# ***Interactive comment on “Theory of the generalized chloride mass balance method for recharge estimation in groundwater basins characterised by point and diffuse recharge” by N. Somaratne and K. R. J. Smettem***

## **Anonymous Referee #1**

Fig. 1.

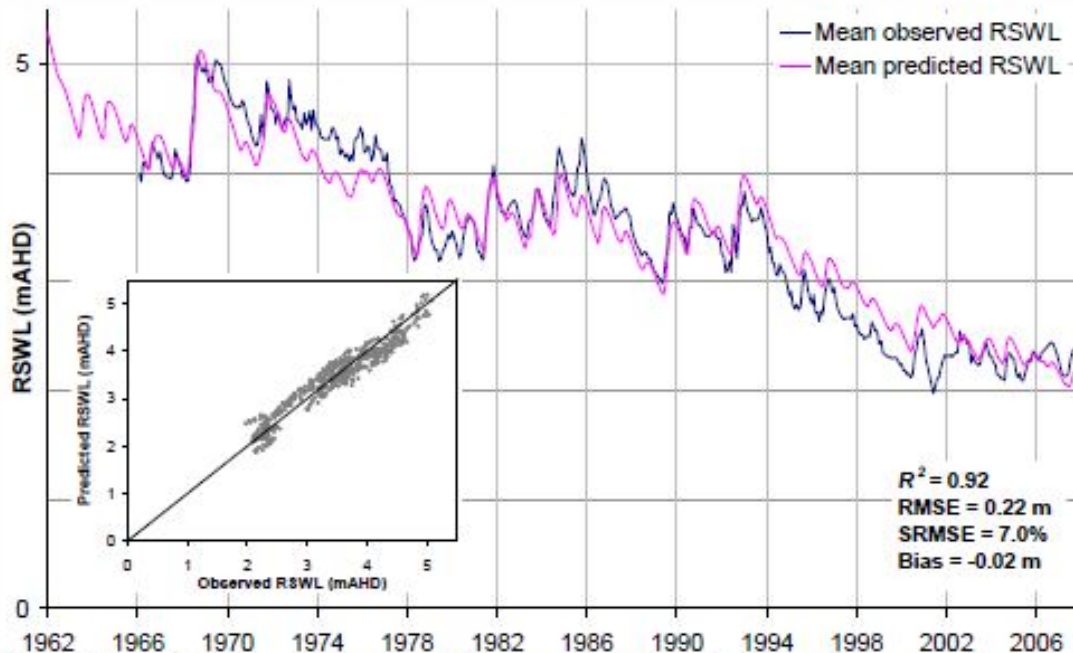
12. It is worth considering some additional evidence in regards to the basic claim by the authors that Uley South recharge ought to be doubled. Uley South has been pumped at rates between about 4 and 7 GL/yr in the recent decade or so. Across the area of the basin (113 km<sup>2</sup>), this is the same as 35 to 62 mm/year of outflow. Despite claims to the contrary, the groundwater storage has most certainly declined (from 1970s to early 2000's - see attached figure from an honours thesis by D. Alcoe showing the average watertable response from several observation wells), then stabilised, and then shown signs of recovery (after 2010), and these stages correspond to periods of higher pumping and then reduced pumping. At its lowest, the water levels in Uley South were marginally higher near the coast to density-corrected sea level, and hence if we consider that discharge to the sea at that time was perhaps small, it seems unreasonable to accept a recharge estimate of 120 mm/year (i.e. twice the high-pumping rate during a period of watertable decline) across the basin, in this semi-arid environment and considering the significant proportion of this uninhabited basin that is thick with vegetation cover. It simply doesn't add up. We can at least infer that recharge has exceeded the lower pumping rate of 35 mm/year, given evidence of watertable recovery.
